STAFF RECOMMENDATION
2918 Westmoreland Dr.
June 20, 2012

Application: New construction—addition
District: Hillsboro-West End Neighborhood Conservation Zoning Overlay
Council District: 18
Map and Parcel Number: 10414005100
Applicant: Preston Quirk, architect
Project Lead: Melissa Baldock, melissa.baldock@nashville.gov

SITE PLAN, 3D VIEWS

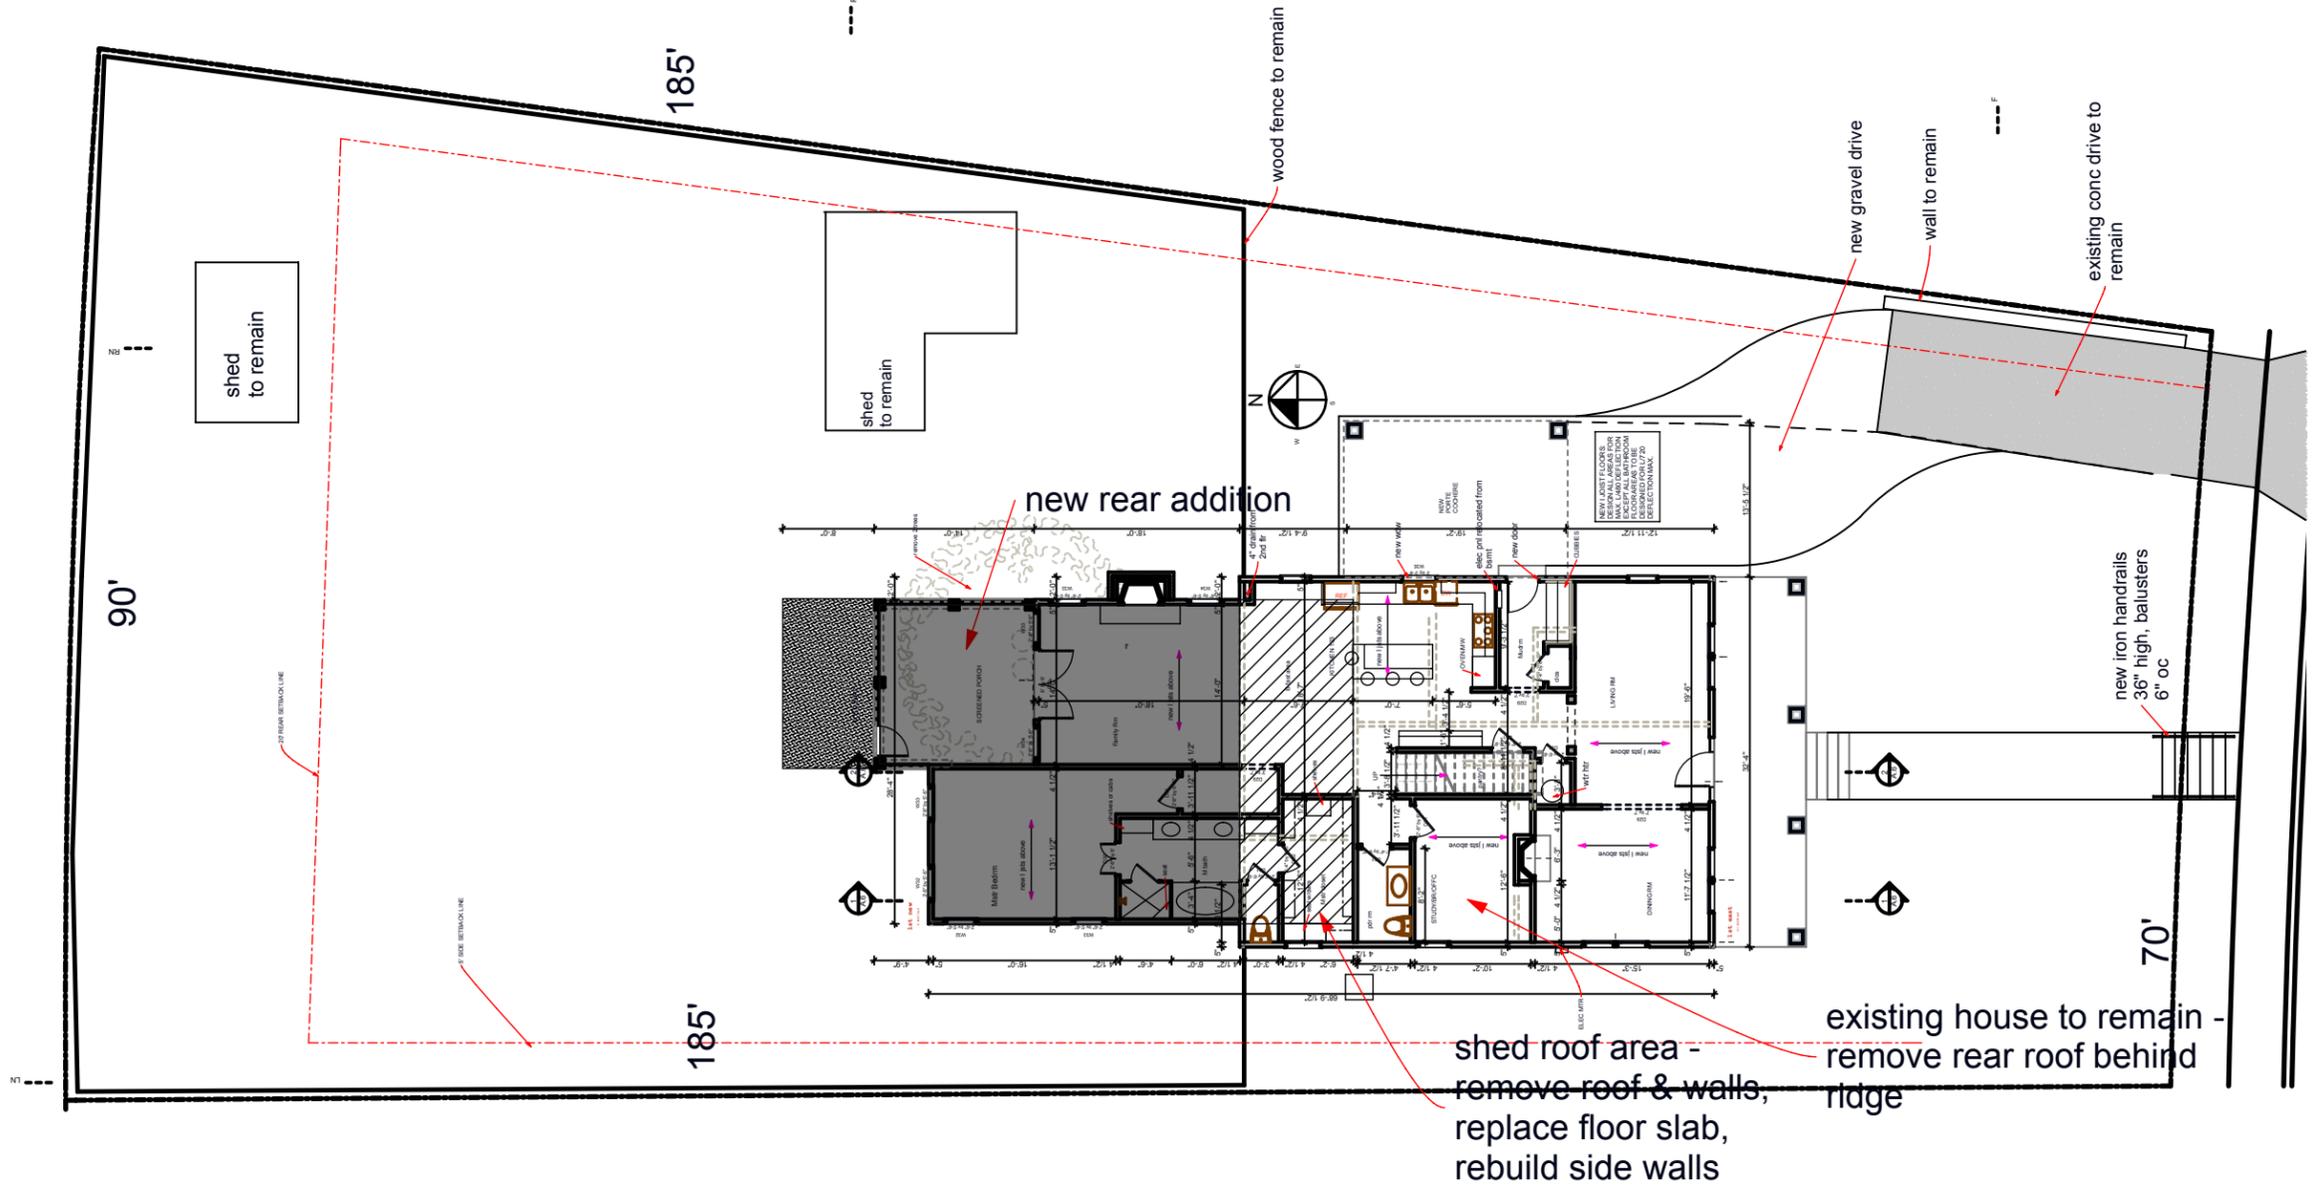
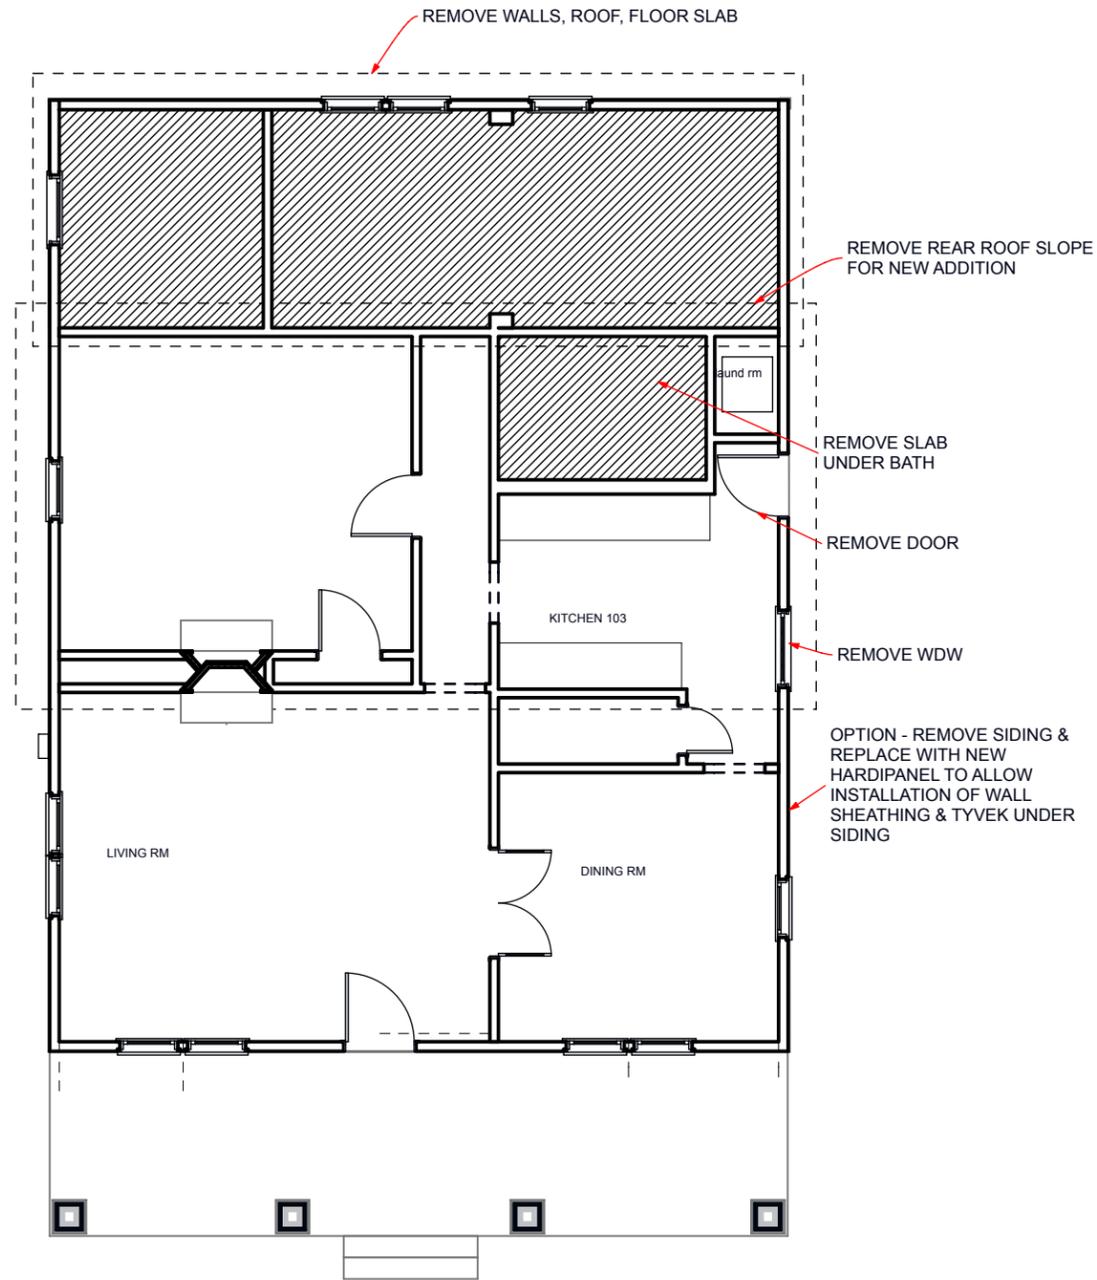
Location and Setback: The new rear addition and side porte cochere meet all base zoning requirements for setbacks. The new porte cochere is proposed for the side of the historic house. The house's lot is irregularly-shaped and is seventy-feet (70') wide at the front and ninety-feet (90') wide at the rear. The lot is wider than the average lot in the Hillsboro-West End conservation overlay, and therefore a side addition is appropriate for the historic structure. The porte cochere will start approximately twenty-one feet (21') behind the line of the front porch. The historic house, with its front porch, is approximately fifty feet (50') deep, and therefore the porte cochere will be located within

The rear addition will be located entirely behind the historic house. It will step in two feet (2') from the rear sidewalls of the house for its entire length. Staff therefore finds the location of the rear addition to meet the design guidelines.

DEMO PLAN

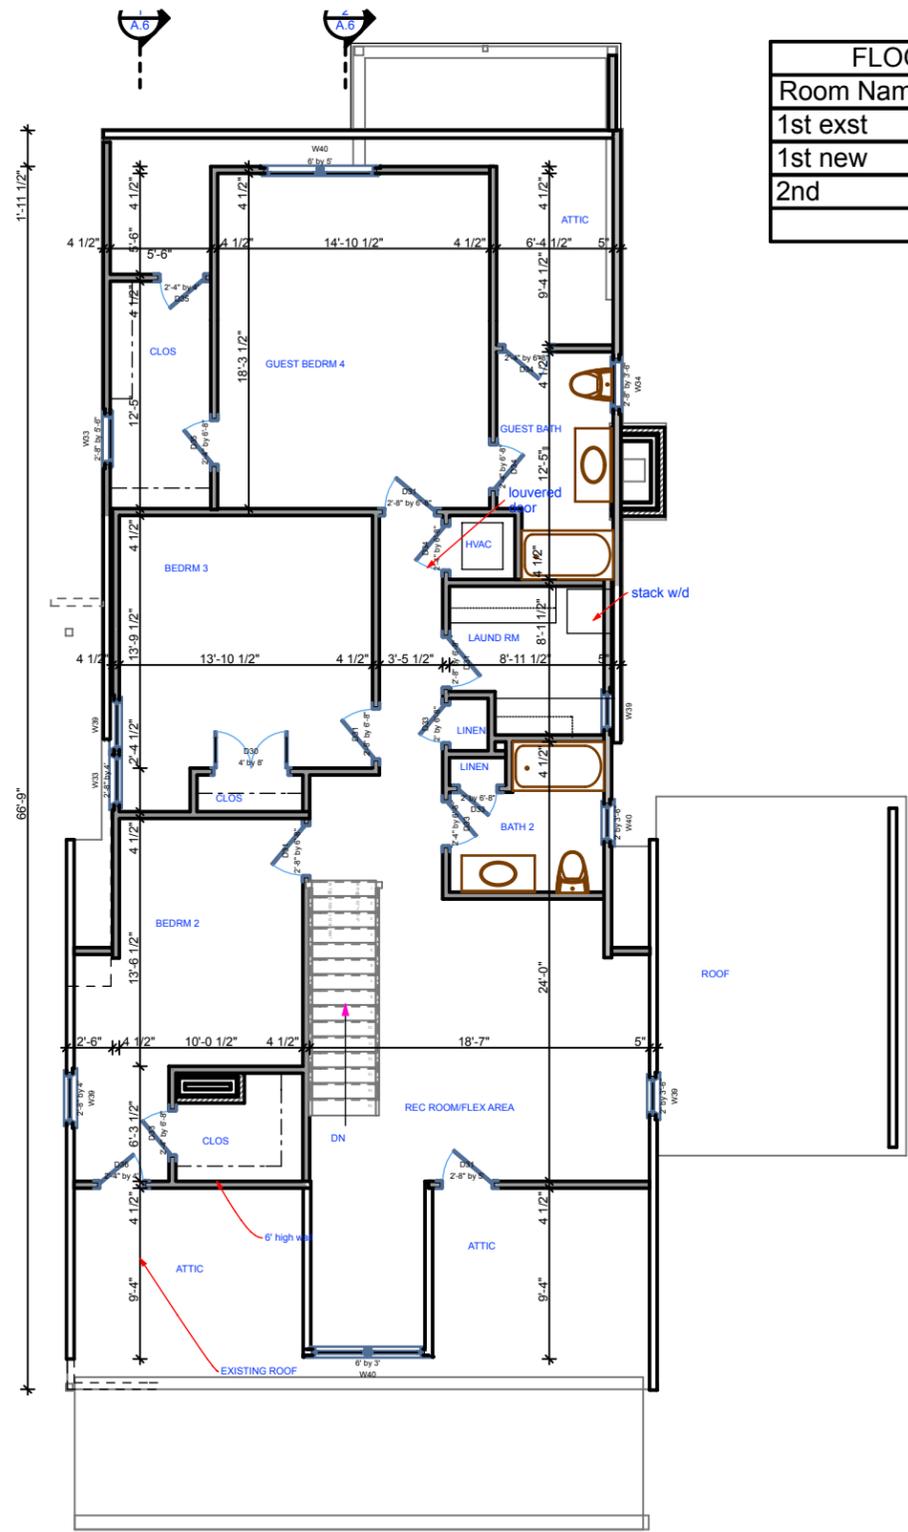
Demolition. The applicant is proposing to demolish and reconstruct the rear ten feet (10') of the existing house. This portion of the structure is not part of the main side-gable form of the house. Staff finds that the demolition of this portion of the house meets the design guidelines because it does not contribute to the historical or architectural character of the house and because it will be reconstructed in the same form. Staff therefore finds that the removal of the back portion of the house meets Section III.B. of the *Hillsboro-West End Neighborhood Conservation Zoning Overlay: Handbook and Design Guidelines*.

ELEVATIONS

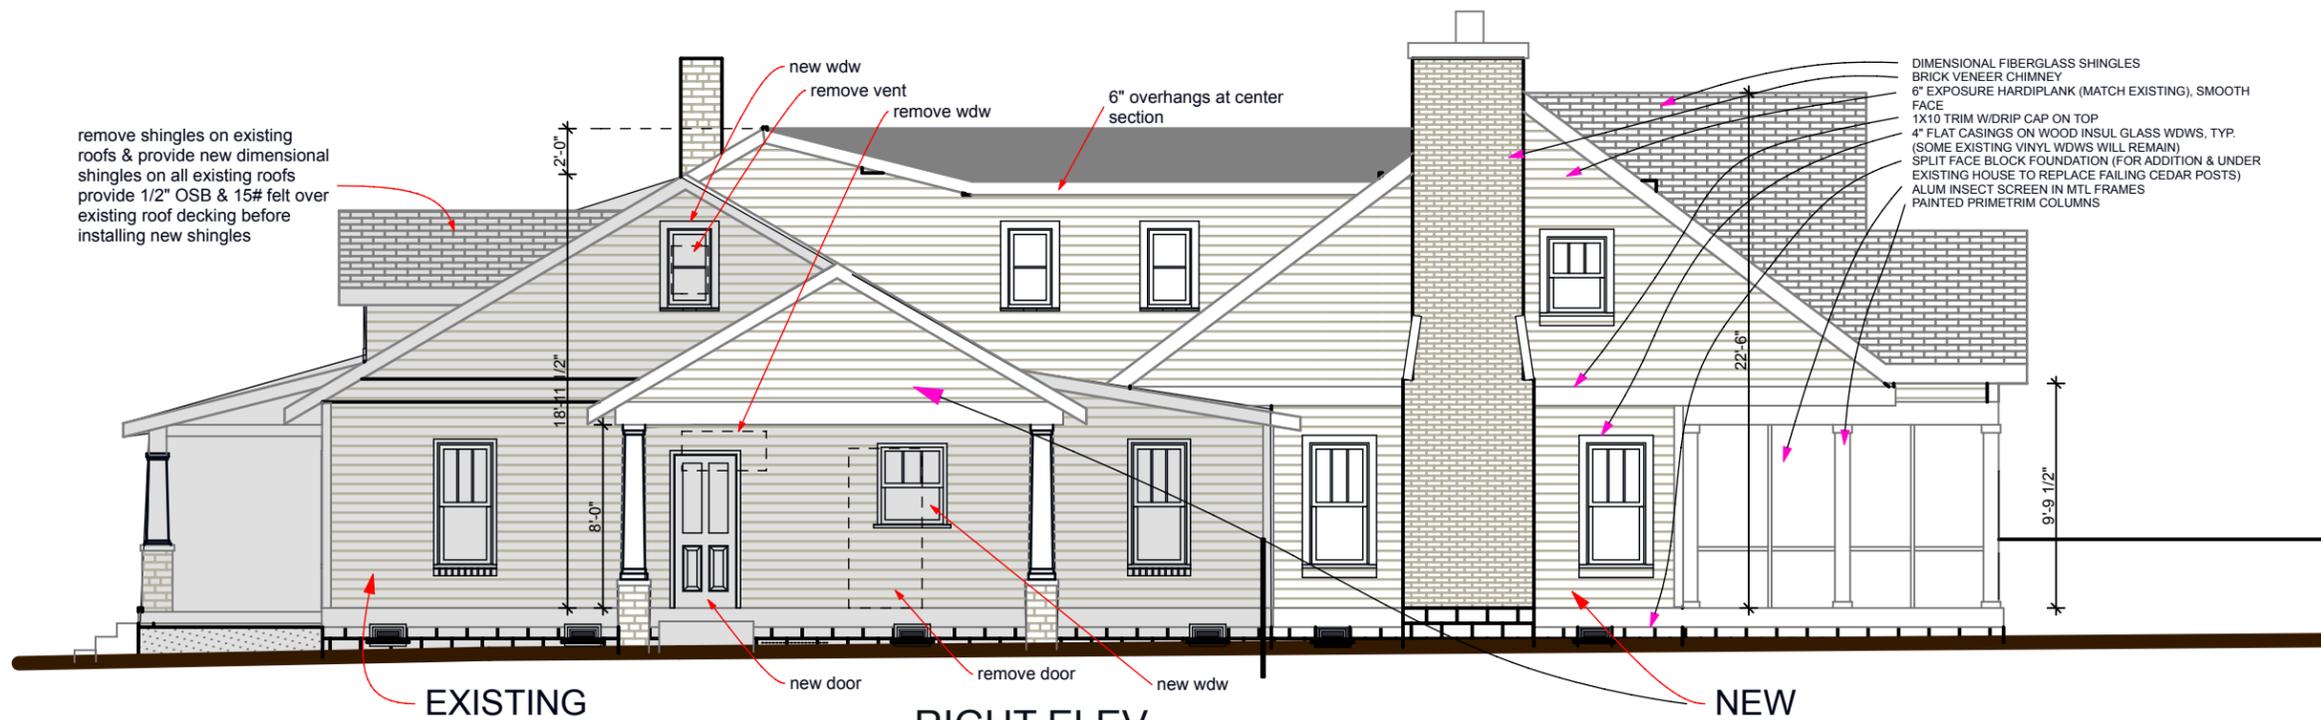
The proposed application involves a ridge raise to the historic house. The ridge raise is inset two feet (2') from each of the sidewalls of the historic house and extends up two feet (2') vertically, following the 7/12 slope of house's roof. Staff finds that the proposed ridge raise meets the design guidelines.

The rear addition has a width of twenty-eight feet, four inches (28'4") and a maximum depth of thirty-two feet (32'). The rear addition ties into the ridge raise and is twenty-three feet (23') in height, or two feet (2') taller than the ridge height of the historic house, for a length of approximately thirty feet (30'). After a depth of thirty feet (30'), the addition becomes a side gabled form that has a ridge height of approximately twenty-five feet (25'). In other words, the side-gabled rear addition has a ridge height that is a total of four feet (4') taller than the ridge height of the historic house. Staff finds this height to meet the design guidelines because the maximum height does not occur until approximately sixty feet (60') behind front of the house, the taller portion of the addition has a side gable form which reduces the impact of its height, and the rear addition is inset two feet (2') from both sidewalls of the historic house.

Proportion and Rhythm of Openings: No changes will be made to the window and door openings on the historic house's front façade. On both the left and right sides of the historic house, the gable field vents will be enlarged to have a two foot by three foot, six inch (2' X 3'6") window opening. On the right side of the historic house, on the ground floor, a horizontal two foot by three foot, six inch (2' X 3'6") window opening will be removed and a new door opening will be created in its approximate location. In addition, a doorway will be removed towards the rear of the house and a new two foot, six inch by three foot, six inch (2'6" X 3'6") window opening will be created. Staff finds these changes to the window openings to be appropriate because they are on the side facades and will not significantly affect the historic character of the house.

The addition's fenestration pattern is similar to that of the historic house. The ground floor windows are largely twice as tall as they are wide, and the second story windows are smaller. There are no large expanses of wall space without a door or window opening. Staff therefore finds the project's proportion and rhythm of openings to meet Sections II.B.1.g. and II.B.2. of the *Hillsboro-West End Neighborhood Conservation Zoning Overlay: Handbook and Design Guidelines*.

1. Staff review and approve the color of the roof shingles, a brick sample, and the window and door specifications prior to purchase and installation of these materials; and
2. The reveal of the siding on the addition match the five inch (5”) reveal on the house.

DATE: 6/6/12
REVISIONS
PROJECT NO: COPYRIGHT 6/6/12 QUIRK DESIGNS
ROOF PLAN
A6 SHEET 6

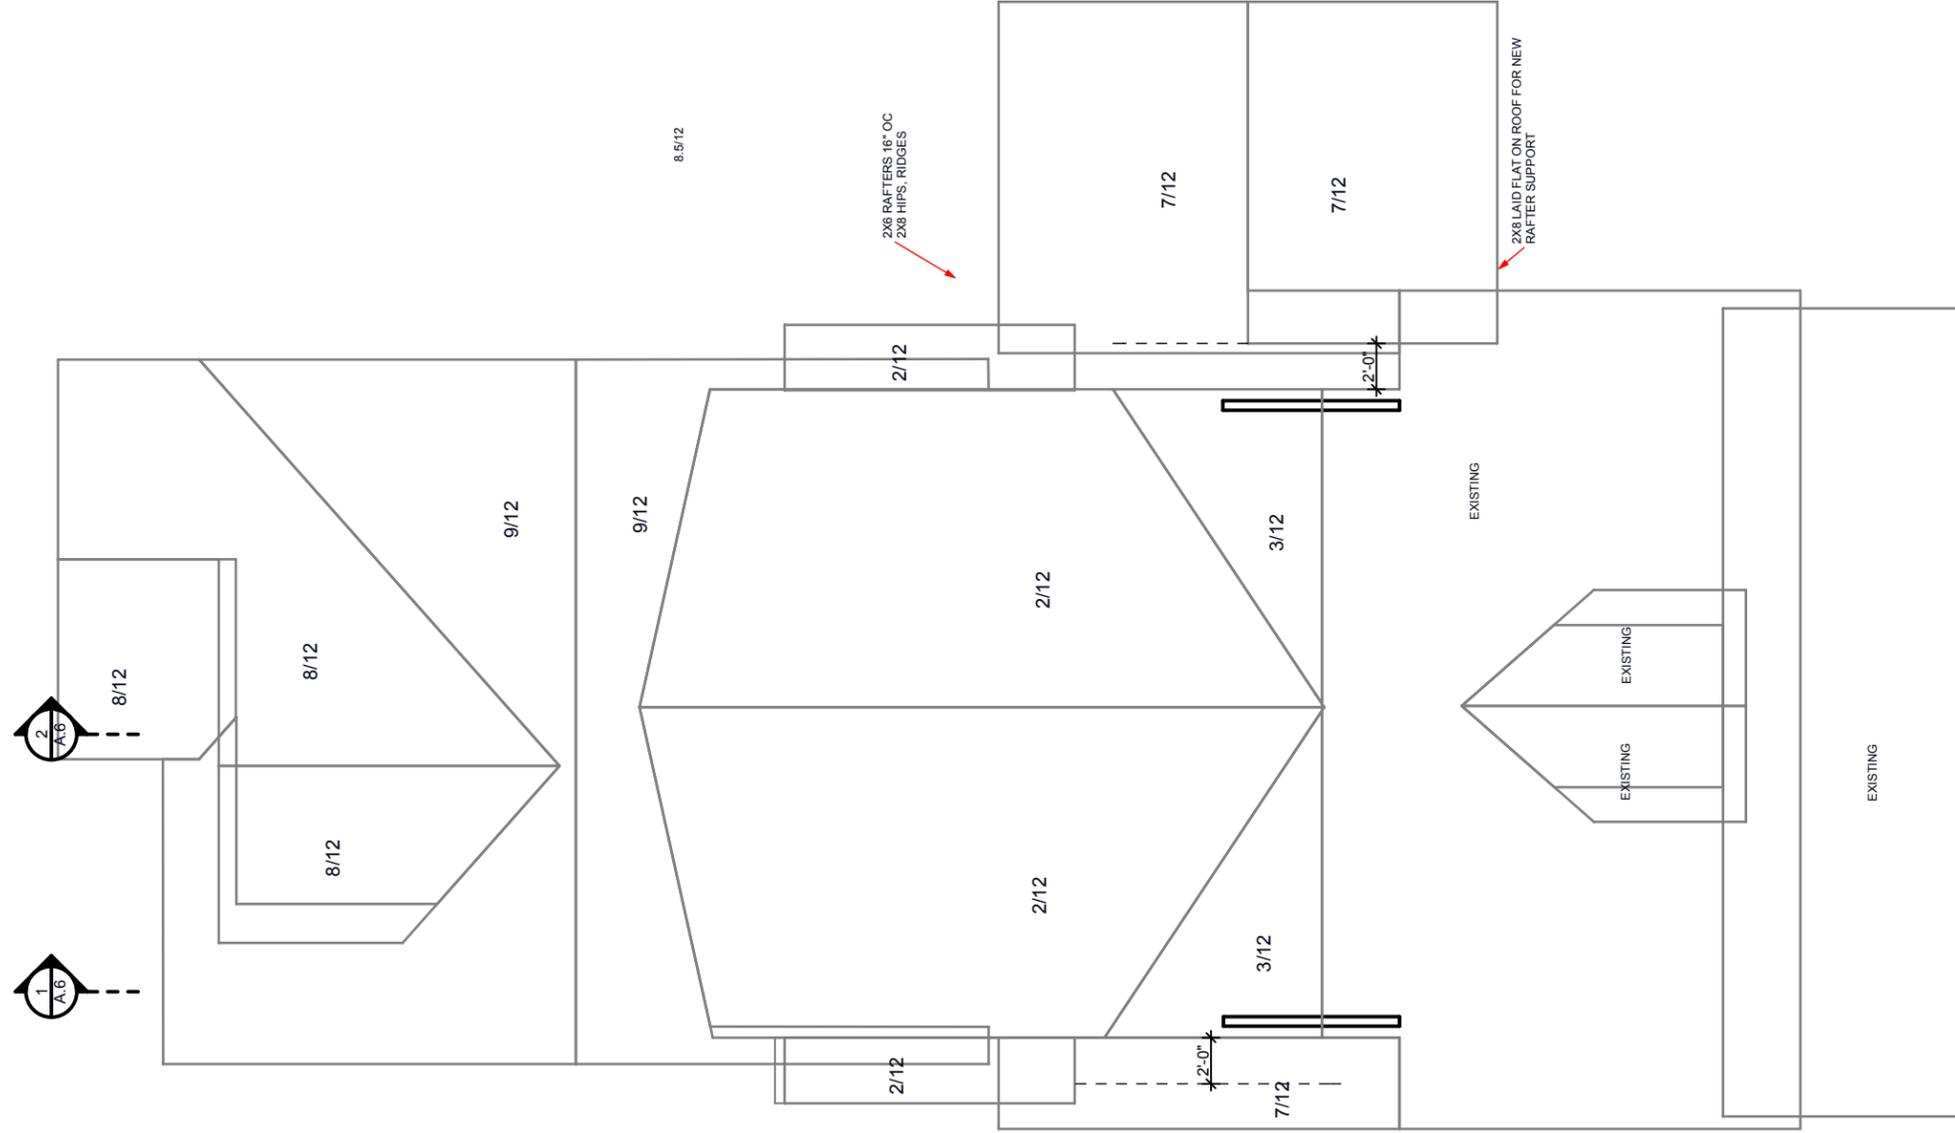
Roof: The historic house's primary roof form is a side-gable with a slope of 7/12. The house includes an existing shed extension in the rear with a slope of 2/12 (this portion of the rear will be reconstructed as part of the project and the roof slope will not change). The side porte cochere will have a side gable form with a slope of 7/12, matching that of the historic house. The rear addition involves a ridge raise, which meets the design guidelines and has a front slope of 7/12. The back slope of the ridge raise will have a 3/12 slope. The portion of the addition that connects the historic house to the taller portion of the addition has gable form with a slope of 2/12. The rear, tall portion of the addition has a side gable form with a slope of 9/12. The rear façade has a gabled dormer and a gabled porch roof, both with 8/12 slopes.

The existing asphalt shingles on the historic house will be removed and will be replaced with dimensional fiberglass shingles. The addition’s roof shingles will match the house’s, and staff asks to review and approve the shingle color prior to purchase and installation. The primary cladding material for the addition will be Hardie plank. The drawings note that the Hardie plank will have a six inch (6”) exposure, “matching existing.” However, staff measured that the existing has a five inch reveal (5”), and therefore staff asks that the siding on the addition match the five inch (5”) reveal of the house. The addition’s foundation will be split face concrete block, and concrete block will also be used under the house to replace failing cedar posts. The chimney will be clad in brick veneer, and the bases of the porte cochere columns will also be brick. Staff asks to review and approve a brick sample prior to purchase and installation.
